Nuclear Operating Company

November 29, 2010
U7-C-STP-NRC-100253

South Texas Project
Units 3 and 4
Docket Nos. 52-012 and 52-013
Revised Response to Request for Additional Information

1. RAI 03.04.02-6, Revision 2
2. RAI 03.04.02-11, Revision 1
3. RAI 03.07.01-25, Supplement 1
4. RAI 03.07.02-24, Supplement 1
5. RAI 03.08.01-4, Revision 2
6. RAI 03.08.01-7, Revision 2
7. RAI 03.08.01-9, Revision 1
8. RAI 03.08.01-10, Revision 1

Figure 3.4-1
Non-Breaking Wave Force on Vertical Wall

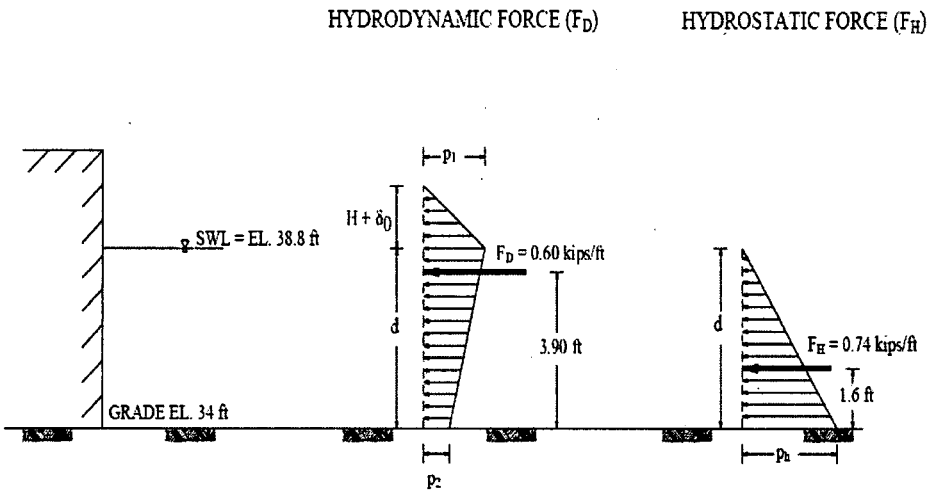
During its evaluation the staff noted that the applicant's response refers to the wave action associated with the postulated river dam breaks located upstream of the Units 3 & 4-site. These events are calculated to result in a maximum flood elevation (including wave action) of 34.4ft MSL, thus only 0.40ft above nominal finished plant grade set at 34.0 ft MSL. The staff agrees that the resulting hydrodynamic and wave loads from those events are not significant. The governing flood event is however the assumed breach of the Main Cooling Reservoir which leads to a calculated flood elevation of 38.8ft MSL or nominal DBFL of 40.0ft MSL. As stated in its response, the fluid analysis has determined a flow velocity of 4.72 fps with an associated hydrodynamic surcharge fluid pressure of 44 psf. For DBFL above finished grade, SRP Section 3.4.2.II(3) requires consideration of wave load effects in the design of Seismic Category I SSC.

In its response the applicant has not evaluated the effect of water waves that may propagate on the water surface of the governing flood event. In its response to RAI 03.04.02-1 (RAI 3322 Question 13161), the applicant also referred to responses to four other RAIs (RAI 03.08.01-4, RAI 03.04.02-2, RAI 03.04.02-4, and RAI 03.04.02-5) for the resolution of RAI 03.04.02-1. The applicant is therefore requested to evaluate the effect of water waves that may propagate on the water surface of the governing flood event, and to track the closure status of the above noted four RAIs. The staff needs this information in order to be able to conclude that the above defined DBF effects are adequately accounted for in the design of Seismic Category I SSC pursuant to SRP Section 3.4.2.II(3).

The resultant hydrodynamic wave force is calculated to be 603 pounds (0.6 kips) per foot length of the vertical wall corresponding to the maximum breach flood level of 38.8 feet. The wave force diagram is shown in Figure 3.4-1, included with the COLA mark-up at the end of this response.

As seen from Figure 3.4-1, the total hydrostatic and hydrodynamic pressure at grade elevation 34'-0" is 339 psf (i.e. considering a sediment-laden water density of 63.85 lb/ft^3, 306.5 psf + 32.5 psf = 339 psf). This pressure is less than the hydrostatic pressure due to conservatively established design basis flood level of 40'-0" (i.e. 6 x 63.85 = 383 psf). Therefore, inclusion of wind generated wave forces does not affect design of below grade walls.

The resultant hydrodynamic wave force is calculated to be 603 pounds (0.6 kips) per foot length of the vertical wall corresponding to the maximum breach flood level of 38.8 feet. The wave force diagram is shown in Figure 3.4-1.

Figure 03.07.01-25.10: Comparison of Unbroadened Response Spectra, Node 105, X Direction EQ Motion, X Direction Response, 5% Damping

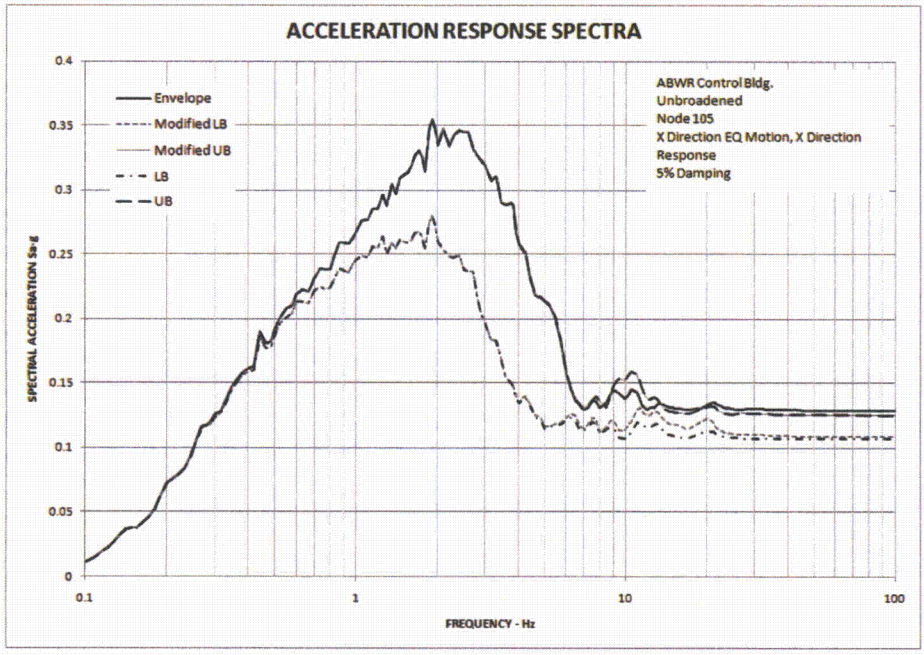
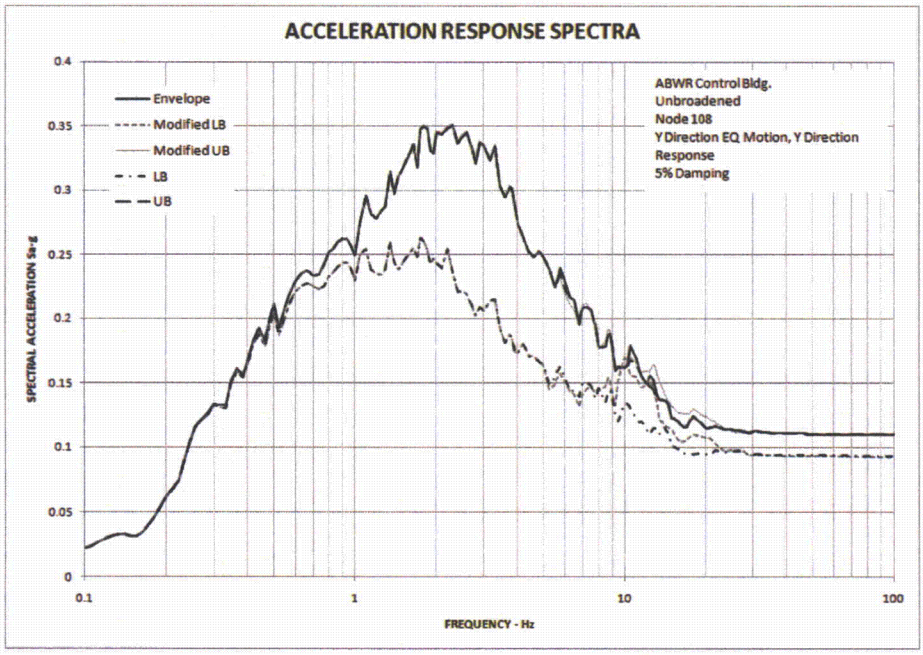
3. In the response to Item 2 of RAI 03.07.01-17, the applicant has stated that the Poisson's ratio has been capped at 0.48 for saturated soils in calculating the compression wave velocity. This results in calculated compression wave velocities lower than 5000 ft/sec in saturated soils when the shear wave velocities drop below approximately 980 ft/sec. For example, as shown in Tables 3H.6-1b through 3H.6-2c (see the enclosure to STP's response to

- In summary, the horizontal response spectra calculated using modified soil properties are enveloped by the original envelope spectra with the exception that some are greater than the envelope by less than about 0.02g at some frequencies, such as around 12.8 Hz in Figure 03.07.01-25.9, around 10.5 Hz in Figure 03.07.01-25.10 and around 13 Hz in Figure 03.07.01-25.14.

Figure 3H.6-212: Lateral Seismic Soil Pressures (psf) on RSW Piping Tunnel East Wall (Main Cross Section of RSW Piping Tunnel)

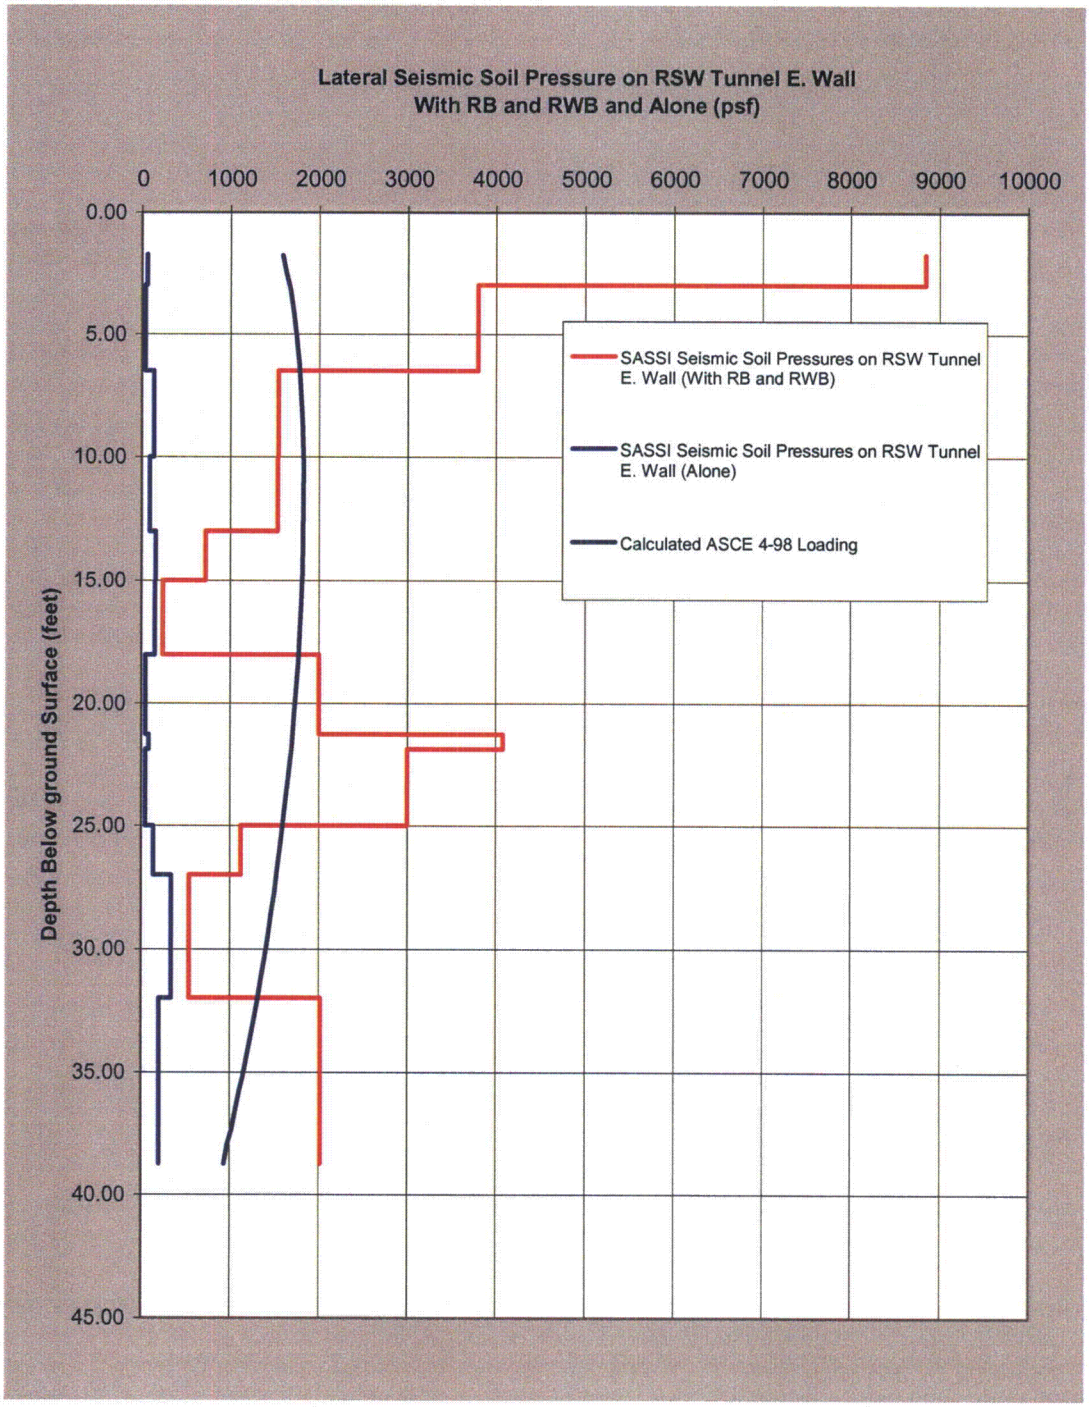
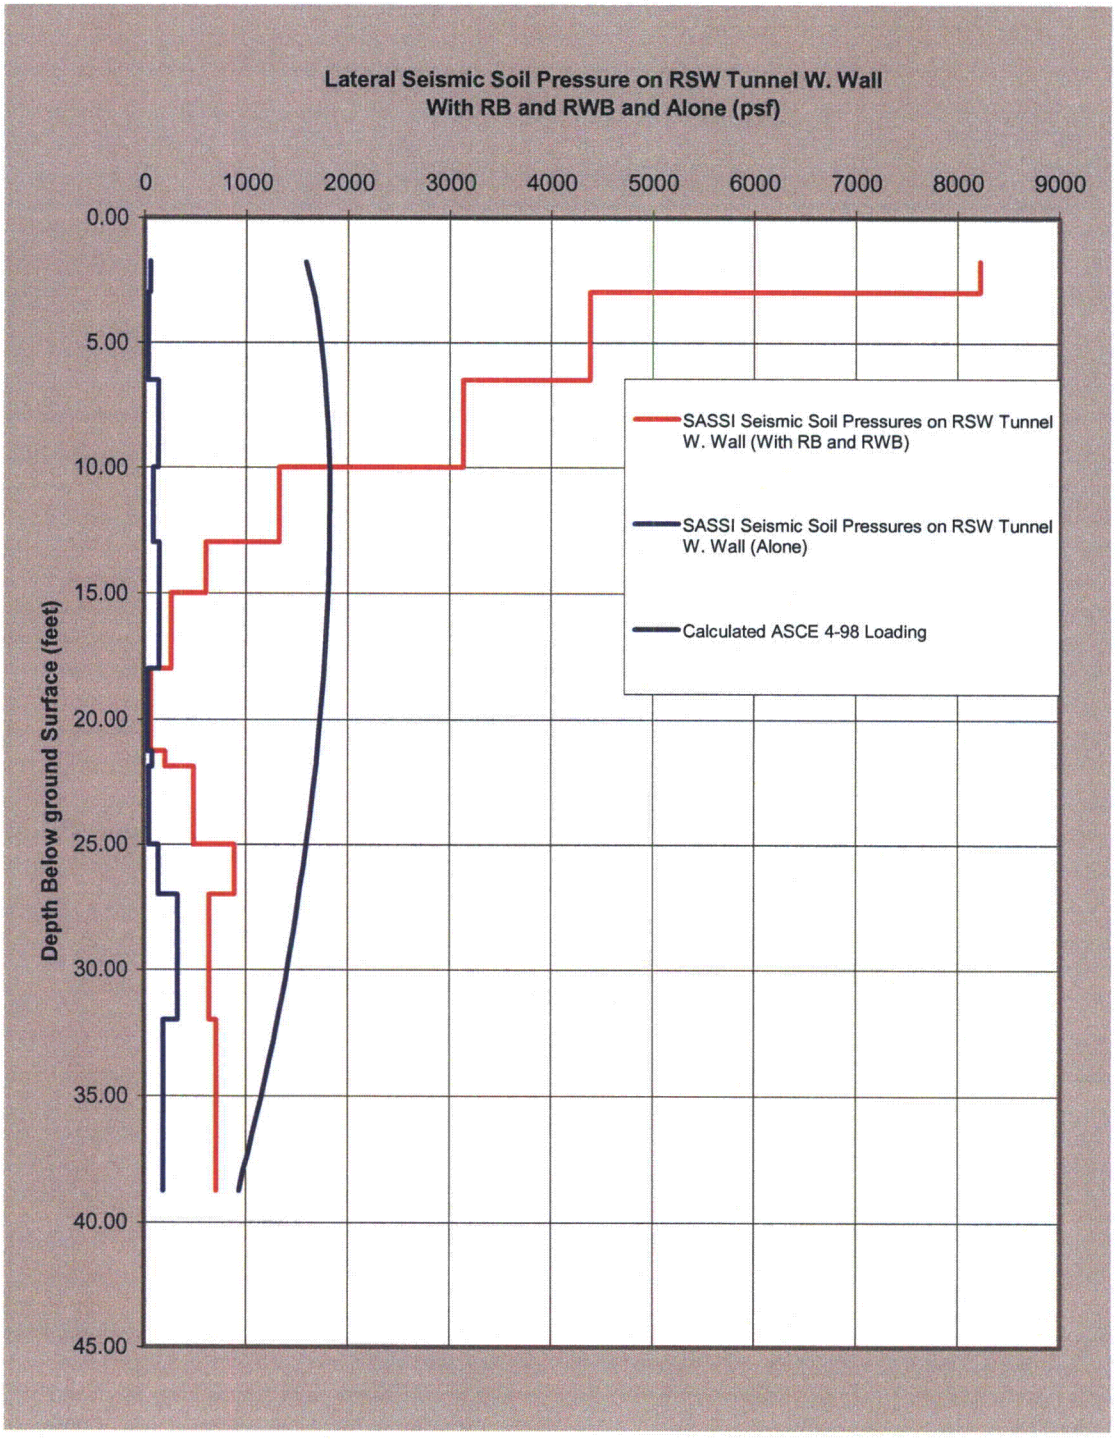
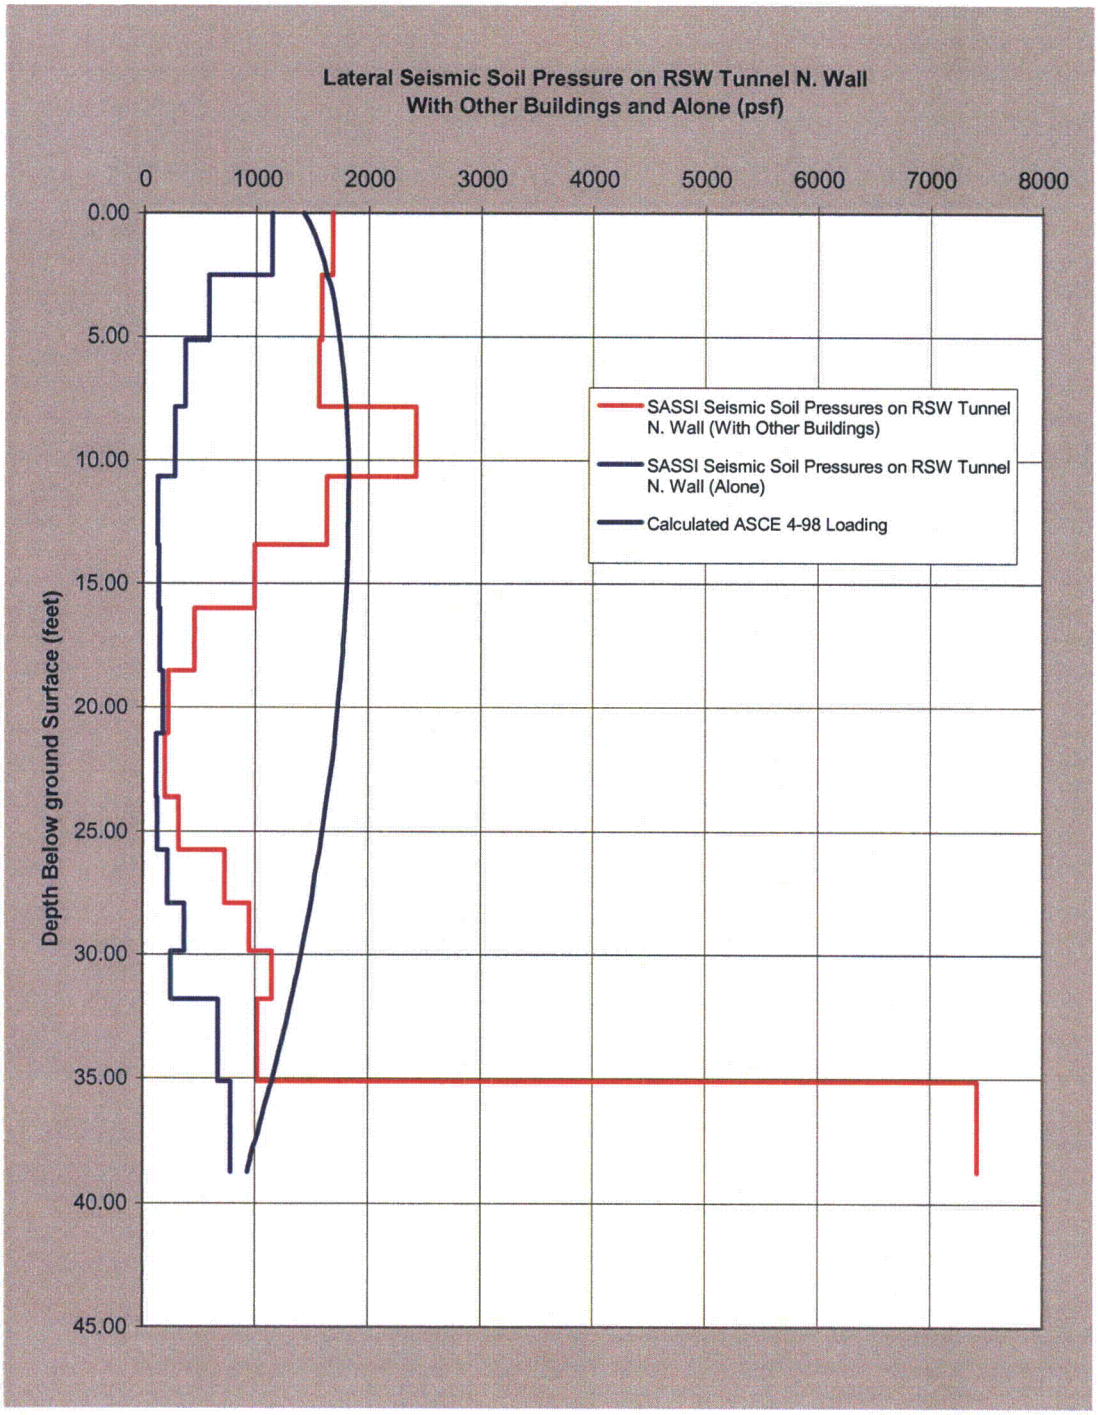
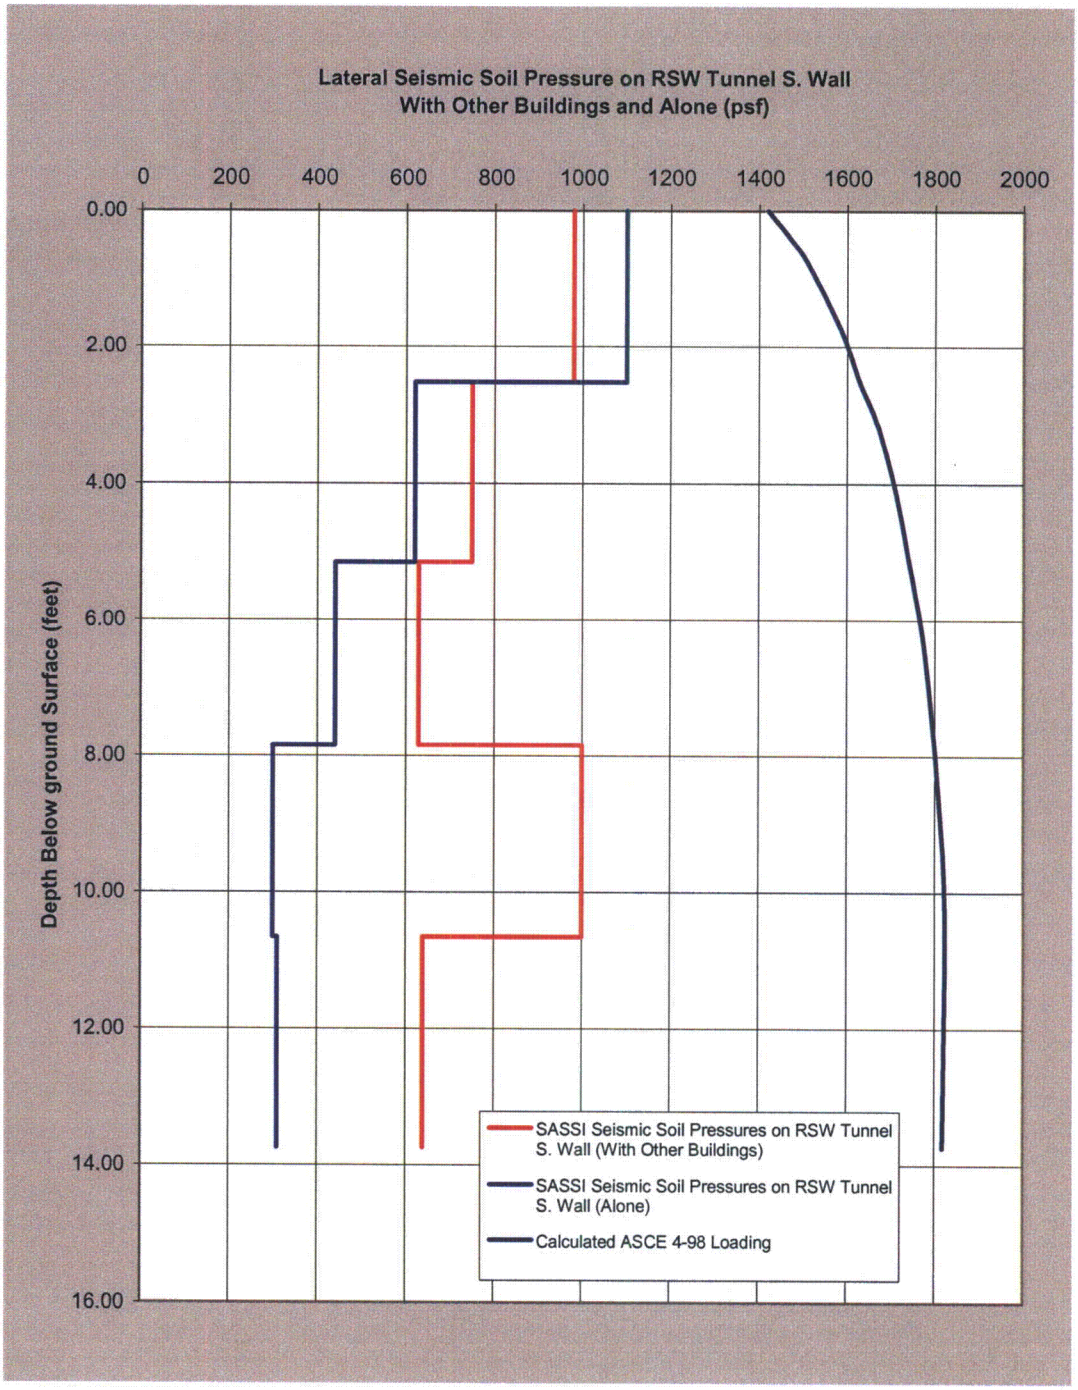
a) Staff has not endorsed ASCE 4-98 Section C3.3.3.4 as acceptable criteria for selecting the cutoff frequency for the SSI analysis for detailed finite element model such as UHS Basin with cooling tower enclosure and RSW Pump House. The applicant is requested to provide comparisons of in-structure response spectra at some selected locations by increasing the frequency cut-off to a minimum of 33 Hz and using a SSI model capable of transmitting a frequency up to 33 Hz (refer to Follow-up Question to RAI 03.07.02-17) for all analysis cases considered demonstrating that cut-off frequencies used in the SSI analysis are acceptable. The staff needs this information to ensure that the selected cut off frequencies less than 33 Hz in SSI analysis will accurately or conservatively account for the expected frequency content of the SSE in the SSI analysis.

Figures 3H.6-212 through 3H.6-215 provide the requested comparison between the seismic soil pressures from the SSSI analysis, as described in Part 1 above, and the calculated seismic soil pressures per ASCE 4-98. The existing design as discussed in response to RAI 03.07.02-15 (submitted with letter U7-C-STP-NRC-100036 dated February 10, 2010) was re-evaluated for the resulting seismic soil pressures from the SSSI analysis. Although the existing design was found to be adequate for these SSSI soil pressures, a portion of the design for the access region near the UHS/RSW Pump House was revised due to design development. COLA Part 2, Tier 2 Table 3H.6-6 is revised to reflect this design change.
